Transmission Expansion Advisory
Committee
May 16, 2019

Scope Change for B3012

Scope History

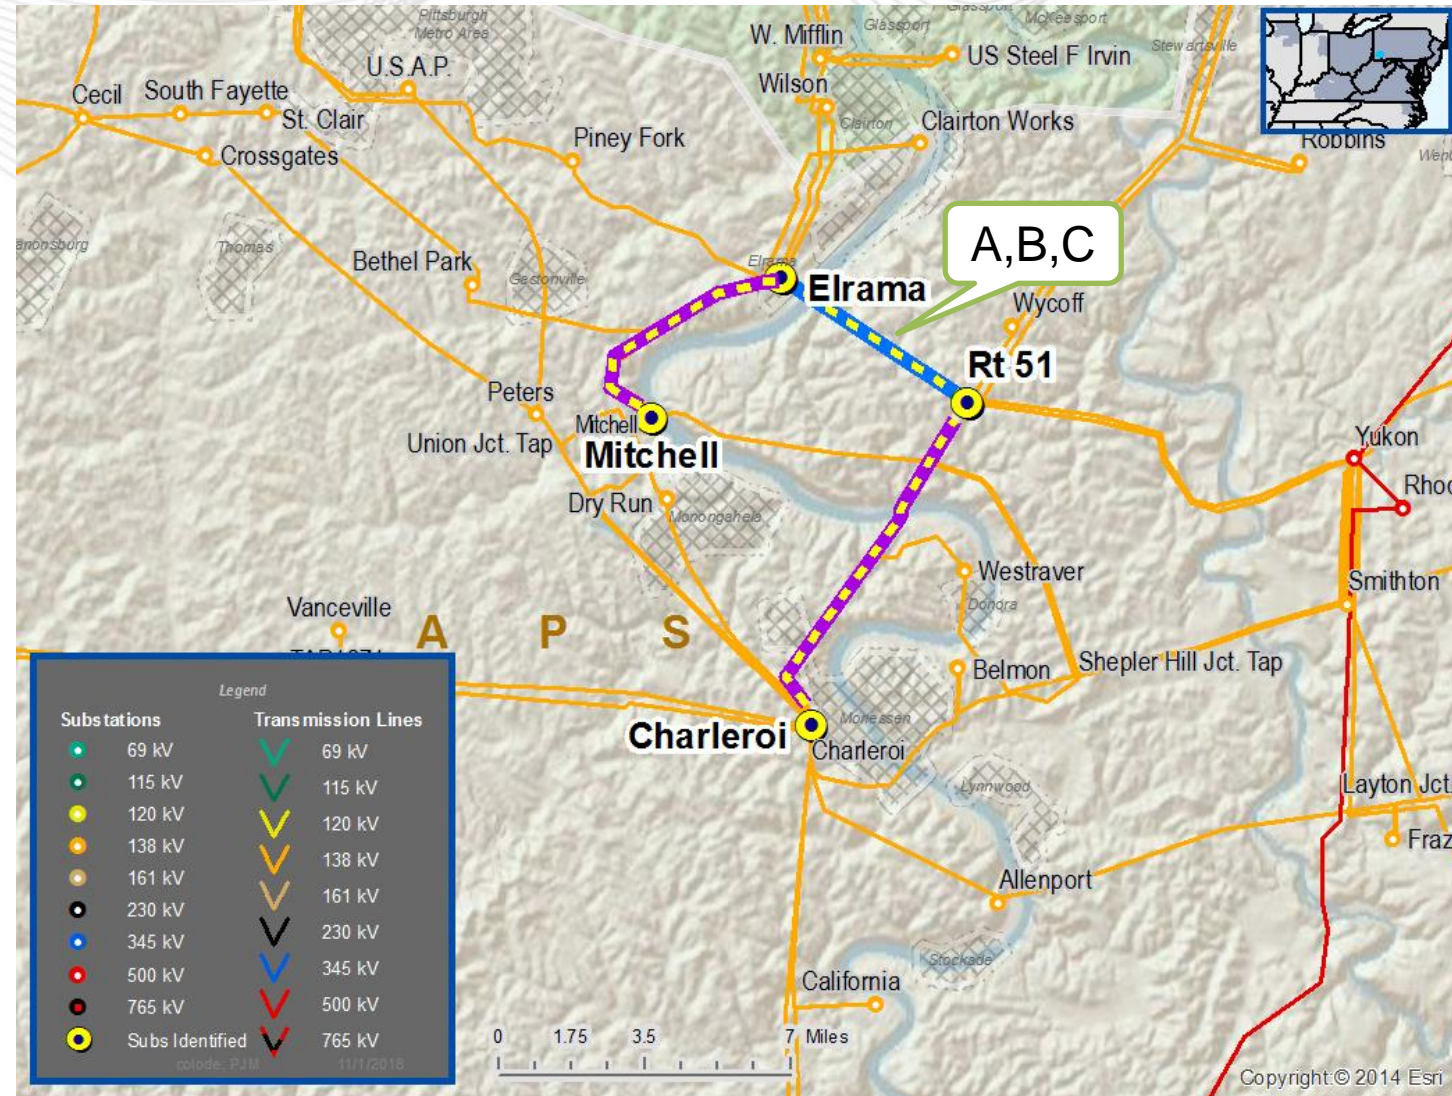
- A. June 7, 2018 TEAC: Initial scope for constructing two new 138 kV ties between Elrama and Route 51 using double circuit construction.
 - Driven by FENOC (nuclear) deactivations
 - Estimated cost: \$9.2M
- B. November 5, 2018: PJM receives FE construction acceptance for b3012
 - FE revised cost and scope to \$23.1M due to detailed estimate;
 - Estimated cost: \$27.7M (FE: \$23.1M; DLCO: \$4.6M)
- C. November 8, 2018 TEAC: Scope revised for additional FES Coal deactivations
 - Separate the two new Elrama – Route 51 circuits onto separate structures to alleviate common structure contingency overloads on the Mitchell - Elrama 138 kV and Route 51 - Charleroi 138 kV #1 and #2 lines.
 - New Estimated cost: \$45.7M (FE: \$41.1M, DLCO:\$4.6M)

Revised Scope (Combine previous B with new D scope)

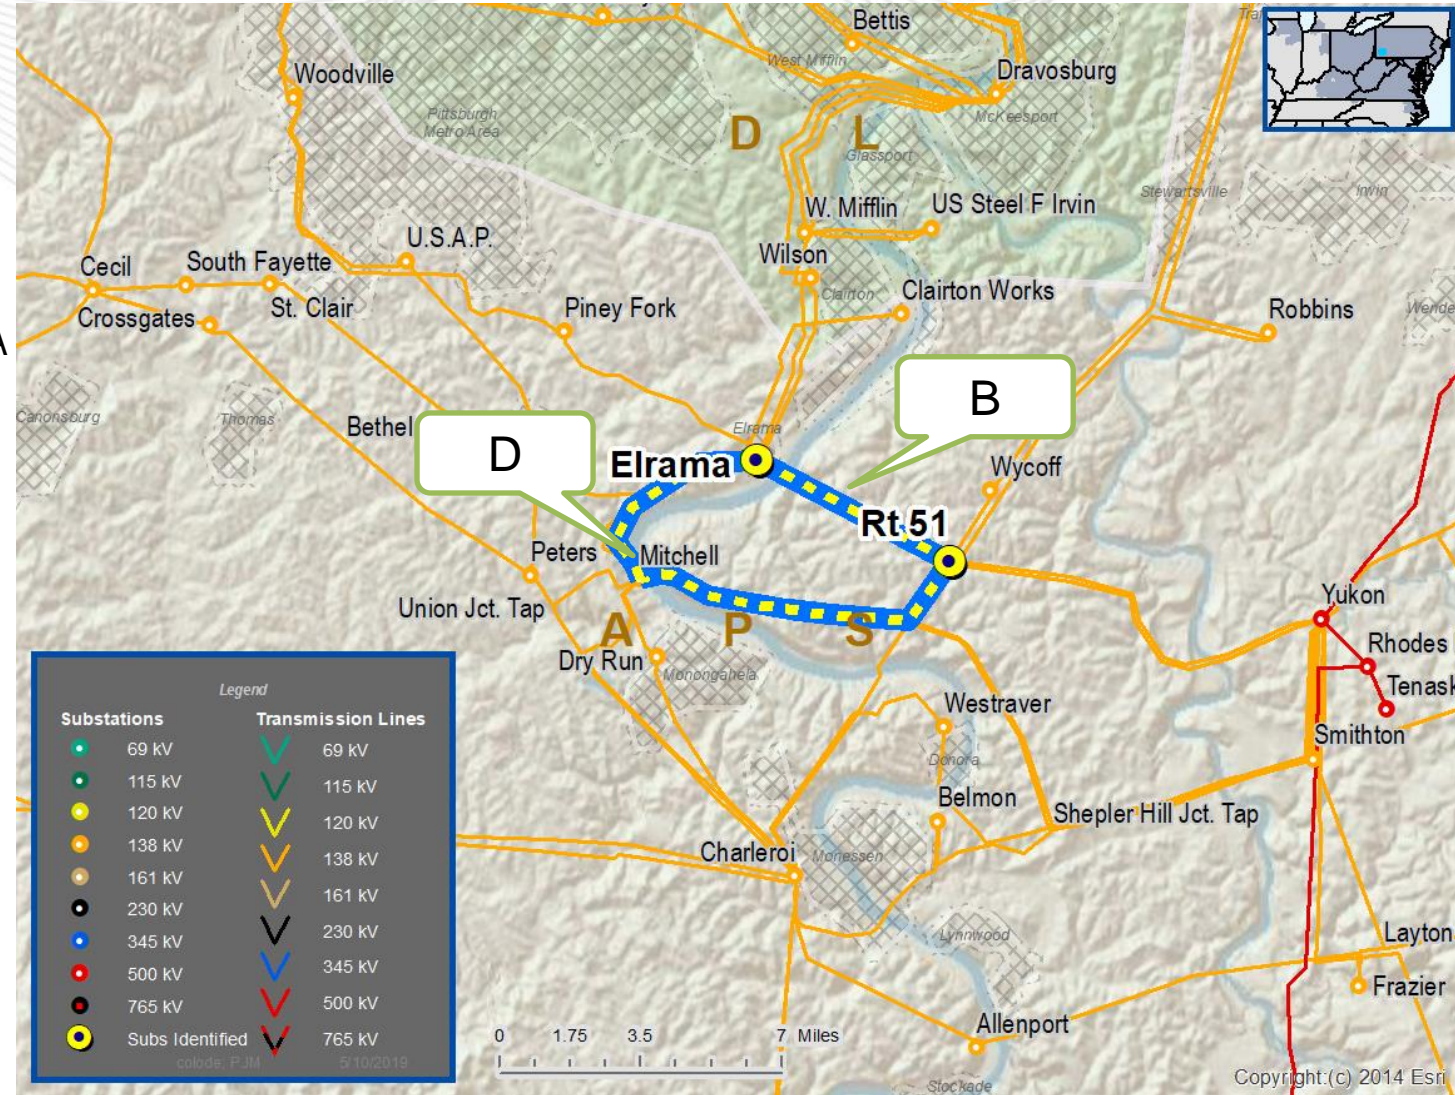
- B. Construct two new 138 kV tie lines using double circuit construction
 - Estimated cost: \$27.7M (FE: \$23.1M; DLCO: \$4.6M)
- D. Construct new Elrama – Route 51 138 kV #3 line (SN 789 MVA / SE 908 MVA).
 - Reconductor ~4.7 miles of the existing double circuit Shepler Hill Jct. – Mitchell 138 kV line (FE). Line will be six-wired.
 - Construct ~1.5 miles of new double circuit 138 kV line from Route 51 to the reconducted portion of the Shepler Hill Jct. – Mitchell 138 kV line (FE). Line will be six-wired.
 - Cut the existing Shepler Hill Jct. – Mitchell 138 kV line at two locations
 - Cut the Mitchell – Elrama line and connect to the former Shepler Hill Jct. – Mitchell 138 kV line. Establishes new tie line in place of the existing Elrama – Mitchell 138 kV line (DLCO).
 - Install one new terminal at FE's Route 51 substation (FE).

Scope Change for B3012 – Continued Revised Scope (Combine previous B with new D scope)

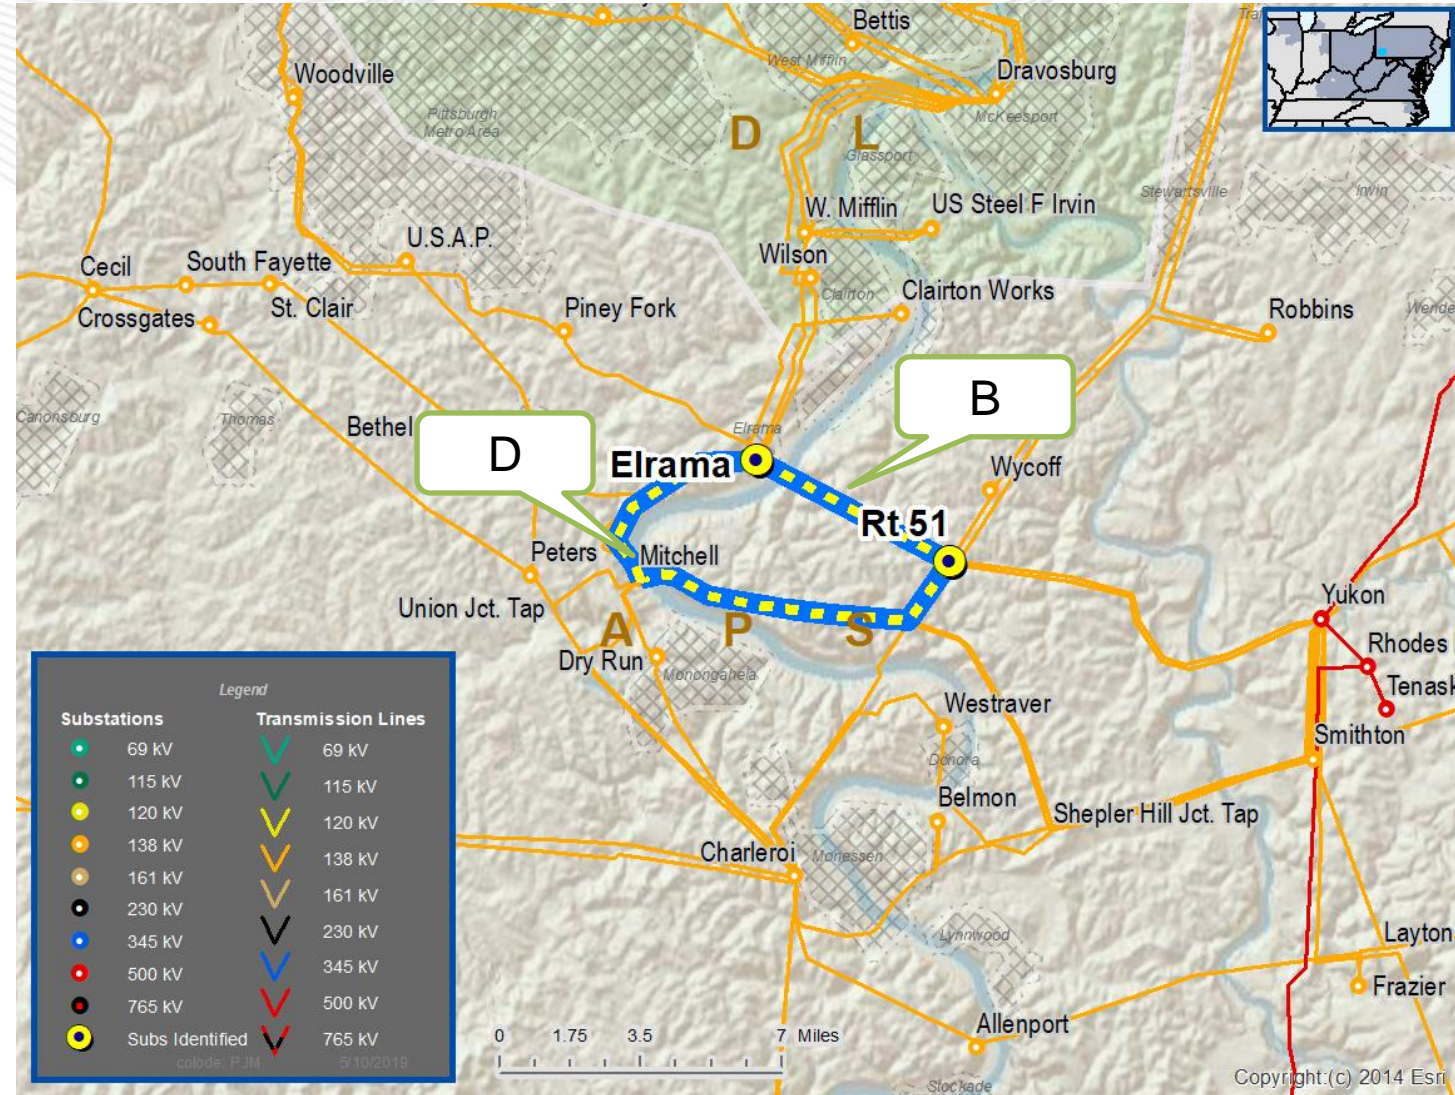
- This project eliminates the need for b2966, which reconductors Yukon - Smithton - Shepler Hill Jct, and replace line disconnect switch at Yukon.
 - o Estimated cost: \$6.7M.

D project cost: \$19.1 (FE: \$18.1M, DLCO:\$1M)

B & D combined cost: \$46.8M
